Service Technical Information

MODEL NO.	TP-M920
SUBJECT	Momentary erase occurs on opposite side of a tape

REF.No. :G - 99 - 021 - E0

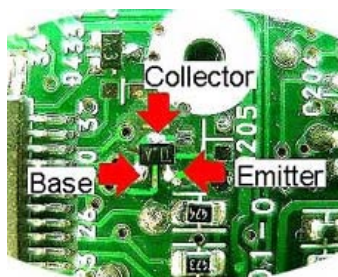
This model erases recorded part on the opposite side of a tape for a moment (approximately 0.8 seconds) at recording start.

Add a transistor (RN2304) between 42nd pin of IC201 (MSM6576) and REC+B.

1) Cut the lines as indicated.

2) Solder the transistor (RN2304).

3) To solder wires to pins of the transistor.
(Length of wires is all 5.5cm.)
